Wisconsin Department of Transportation

**Proposal #34: 1035-04-71, WISC 2018 170
N-S Freeway, Ken&Rac Work Zone Prep
Sth 142 to Cth G
IH 41
Racine & Kenosha County**

This is Addendum No. 01, which provides for the following:

Addendum No. 01
ID 1035-04-71
Revised Sheet 24
January 29, 2018

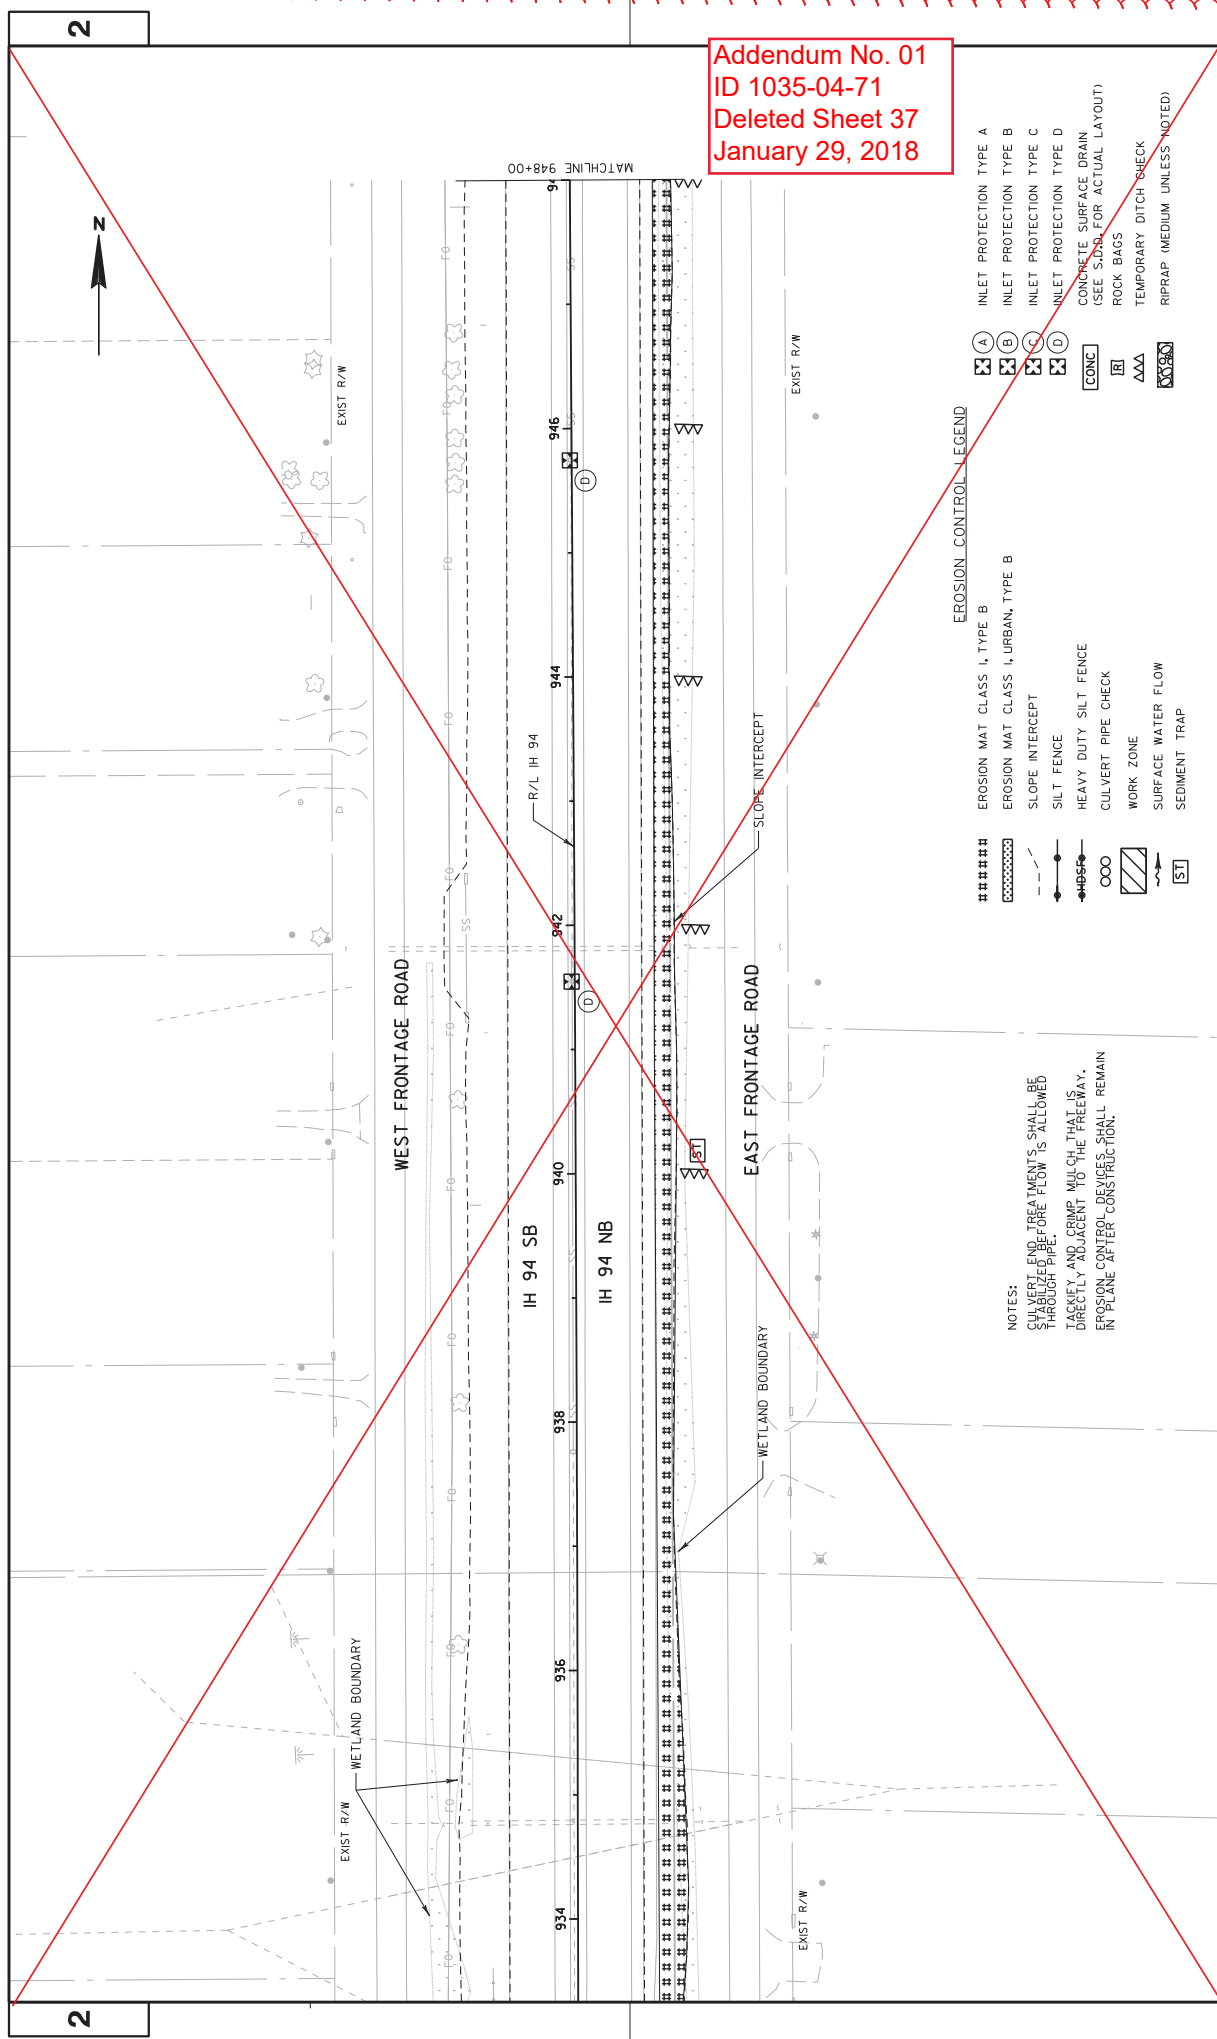
Revised Plan Sheets	
Plan Sheet	Plan Sheet Title (brief description of changes to sheet)
8-9	Project Overview (Revised Temporary Widening Notes)
11	Typical Sections (Revised Pavement Repair labels)
18, 22, 24	Construction Details (Revised relief trench, butt joint, shldr repair, and vane drain locations)
50, 51, 53, 54	Erosion Control (Revisions based upon staging switch)
66	Traffic Control (Revised Legends and Notes)
68-69	Traffic Control Overviews (Revisions based upon staging switch)
70-75	Traffic Control Typical Sections (Revisions based upon staging switch)
76-175	Traffic Control Detail Sheets (Revisions based upon staging switch)
179	Alignment Layout (Crossover alignment no longer needed)
217-220, 222-228, 232-242	MQ (Revisions based upon staging switch)
249-250, 256-268	Plan (Revisions based upon staging switch)
367, 368, 370, 371, 378-381	Earthwork (Revisions based upon staging switch)
440-456, 506-515	Cross Sections (Revisions based upon staging switch)

SHEET 121G

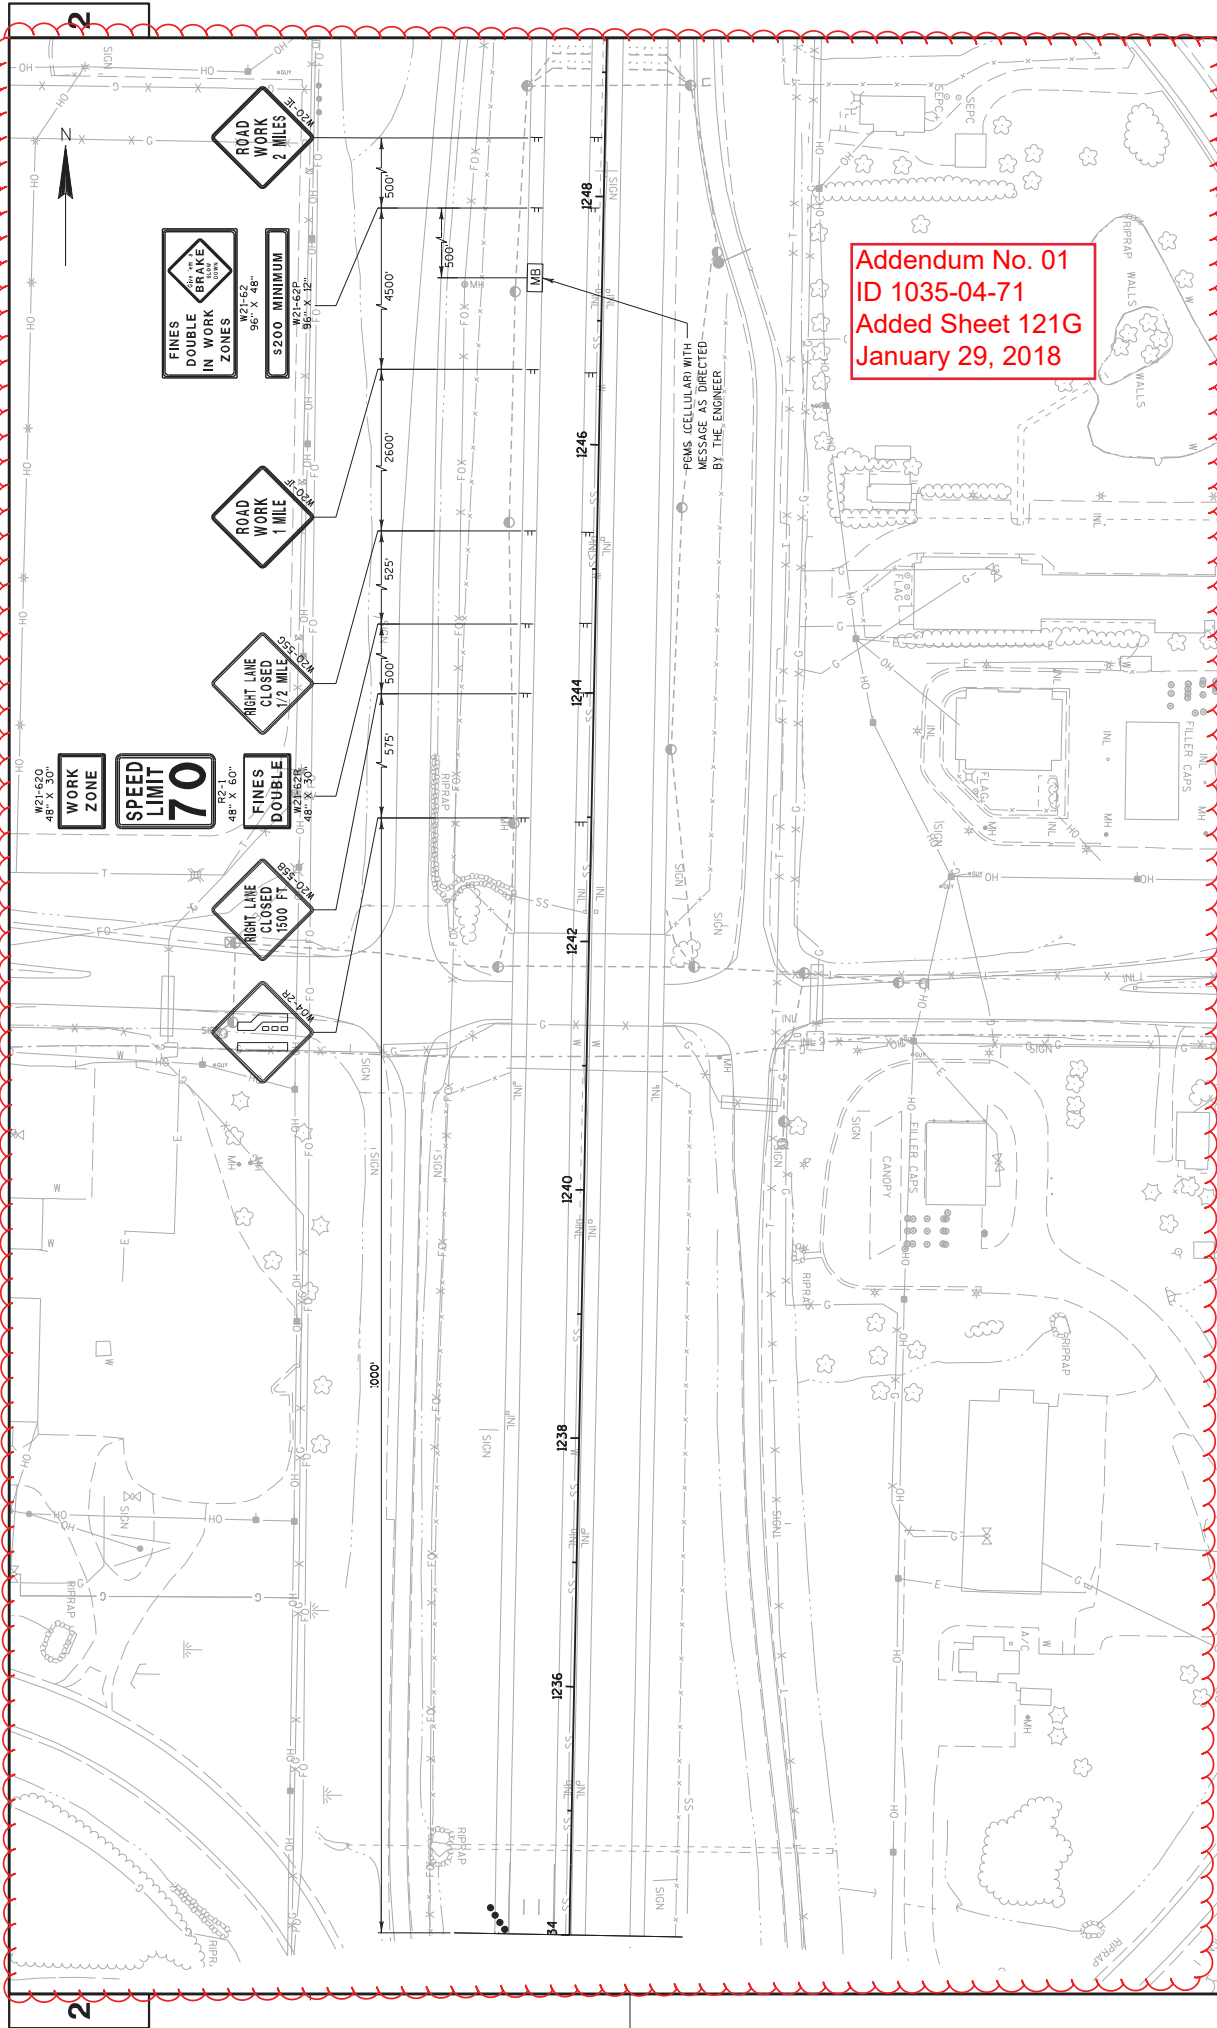
Added Plan Sheets	
Plan Sheet	Plan Sheet Title (brief description of changes to sheet)
121A-121G	Traffic Control Detail Sheets (Revisions based upon staging switch)
227A-227B	Miscellaneous Quantities (Revisions based upon staging switch)
239A	Miscellaneous Quantities (Revisions based upon staging switch)
